Subject: **STRUCTURAL INVESTIGATION OF THE LUNADA BAY LITTLE LEAGUE
SNACK SHOP - PALOS VERDES PENINSULA USD**

It is our understanding that the Lunada Bay Little League Snack Shack building, Division of the State Architect (DSA) Application No. 03-102808, was constructed without DSA's oversight thus was subsequently not closed-out. As part of DSA's request from the District, we performed a structural investigation of the building. Our structural investigation included review of available record drawings, performance of a visual site observation, and preparation of this structural report outlining out structural findings and recommendations.

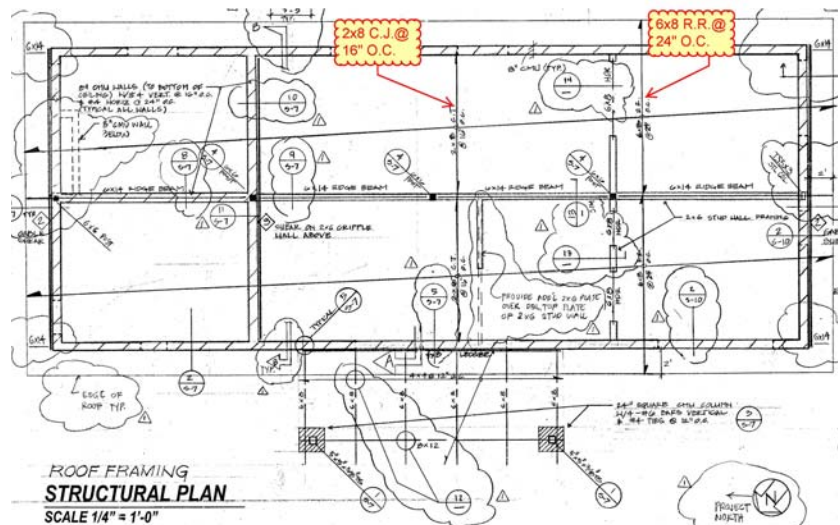
As indicated in the record drawing roof framing plan to the right, the existing roof framing system was to be constructed of 6x8 roof rafters (R.R.) spaced at 24" on-center. Instead, the existing roof rafters are 2x8 spaced at 16" on-center. Also, hardware such as the 2 1/16" wide Simpson MSTI ridge steel straps specified on the drawings to tie the 6x8 framing would not be recommended for installation on the existing the 1 1/2" wide 2x8 framing if installed.

The 2x8 at 16" on-center hard lid ceiling joist (C.J.) framing system serving to tie the interior wood framed walls and perimeter block walls together was not constructed.

Based on our review of the DSA-approved drawings and visual observation of the exposed conditions, it appears that the as-built existing roof framing system substantially deviates from the DSA-approved design. We anticipated that the existing roof framing system will need to be either seismically strengthened or replaced in its entirety to provide the vertical and lateral (seismic) capacity to meet the California Building Code minimum structural requirements.

5 OPENING IN ROOF
N.T.S.

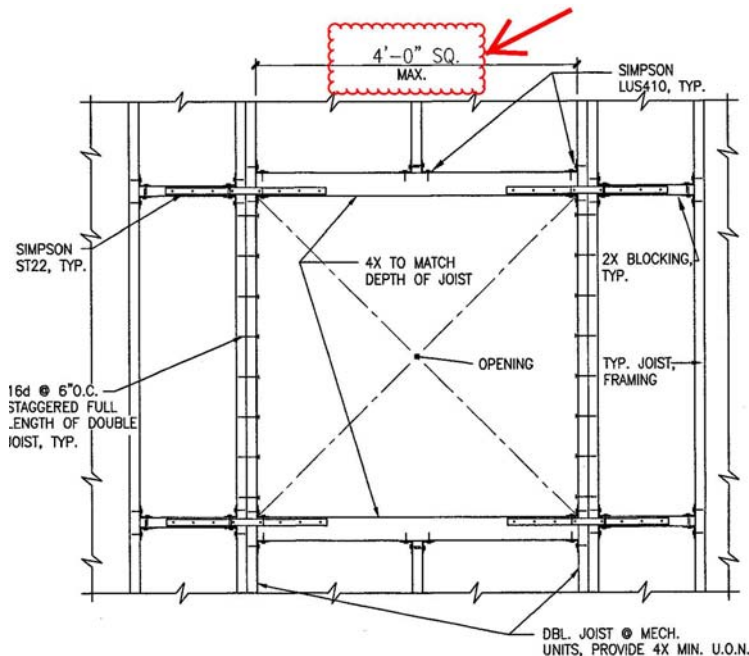
The two existing roof skylights installed are larger than the maximum 4'-0" opening size as shown on the DSA-approved typical drawing detail attached to the right. It is unknown how the skylight opening framing was reinforced or if straps were installed. It should also be noted that no skylights are shown on the DSA-approved roof framing plan. The current skylights are large and would require the roof seismic diaphragm to be reinforced.
